**Project:** Springfield City Hall Renovation (2021)  
**Title:** Addendum No. 01  
**Date:** October 18, 2023  
**From:** PIVOT Architecture  
**To:** Interested Bidders

**1 FLOOR PLAN - CM OFFICE**  
1/4" = 1'-0"

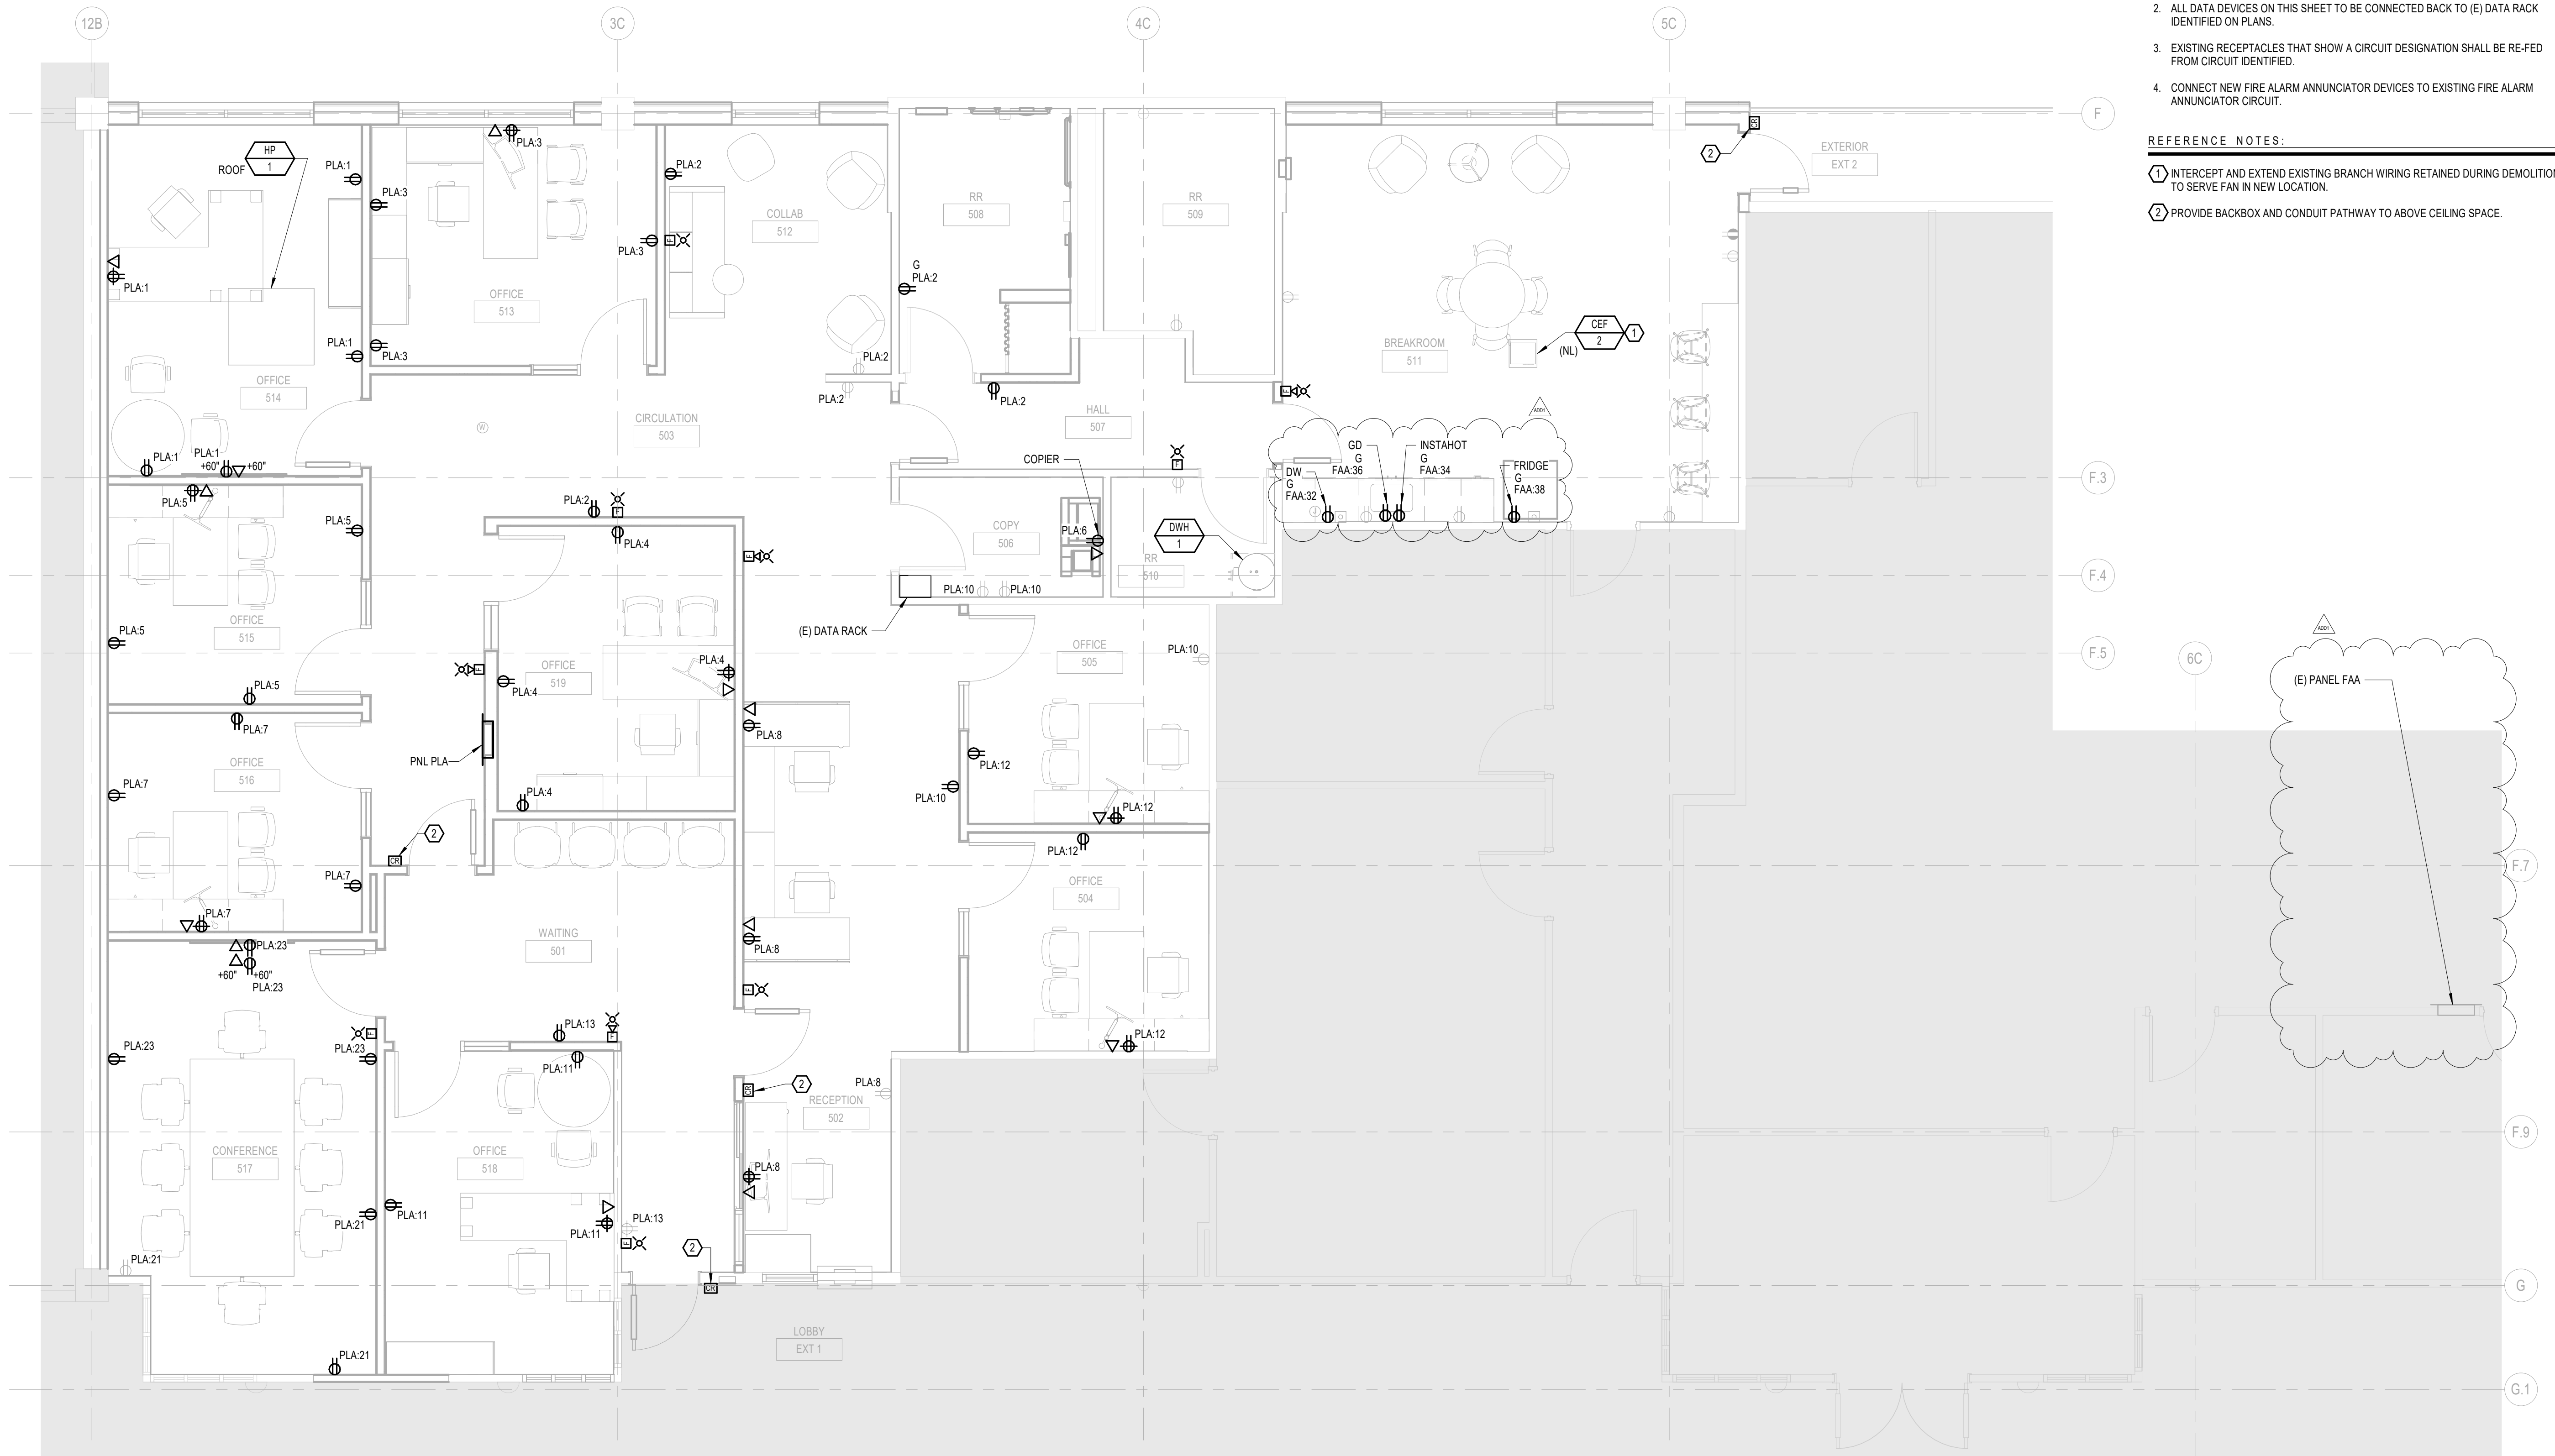
- 2.1. E121 – FLOOR PLAN - CM OFFICE dated 06.22.2023
- 2.1.1. (Reissued) – Revised break room circuits at kitchenette to be fed from panel FAA.
- 2.1.2. (Reissued) – Identified location of panel FAA.
- 2.2. E601 – SCHEDULES dated 06.22.2023
- 2.2.1. (Reissued) – Revised panel details and circuiting on panel PLA.
- 2.2.2. (Reissued) – Revised mechanical equipment details and circuits on Mechanical Equipment Connection Schedule.
- 2.3. E602 – SCHEDULES dated 06.22.2023
- 2.3.1. Issued sheet E602 to provide panel schedule for panel FAA.

**1 ONE-LINE DIAGRAM**  
NOT TO SCALE

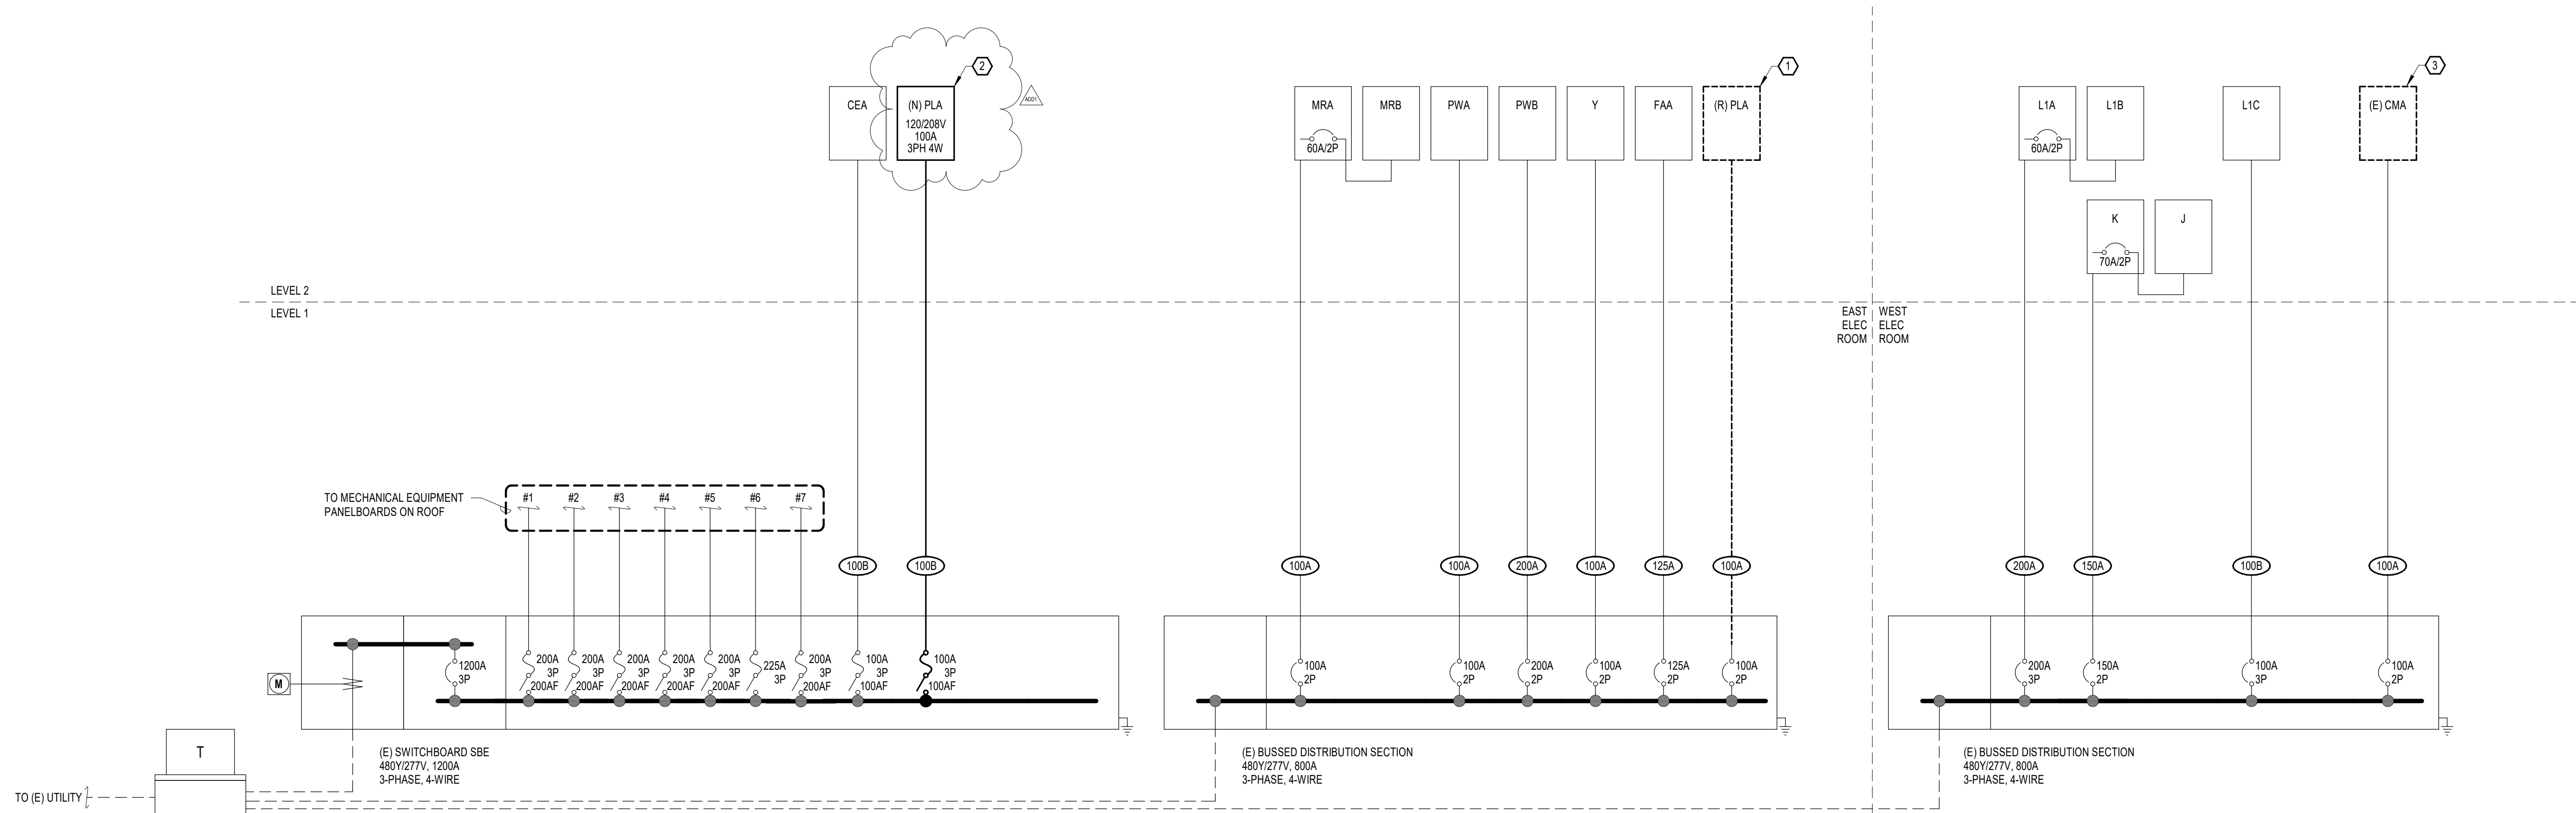
- 1.1. **Q.** Do we have a Feeder Schedule for the one-line diagram on E621? Looks like we are providing a 225A new panel PLA and attaching it to an existing 100A breaker in SBE. Are we sizing the conduit and feeder for 100A or 225A? If we are sizing it for 100A can we reuse the existing conduit and feeders feeding PLA's old location, set a j-box and extend it to the new location. I'm pretty sure it's an overhead feed to the old location. If we are sizing it for 225A, I need the conduit and feeder requirements along with length of path back to SBE.

2.4.1. (Reissued) – Revised panel PLA size to 100A from 225A

2.4.2. (Reissued) – Added feeder schedule.

**A.** Panelboard will be 100A per addendum 01 with feeder size provided in addendum.
- 1.2. **Q.** Can you confirm the water heater requirements? There is a conflict between Plumbing Eq. schedule and our Electrical Eq. Schedule. What is the size of the power to the hot water tank?
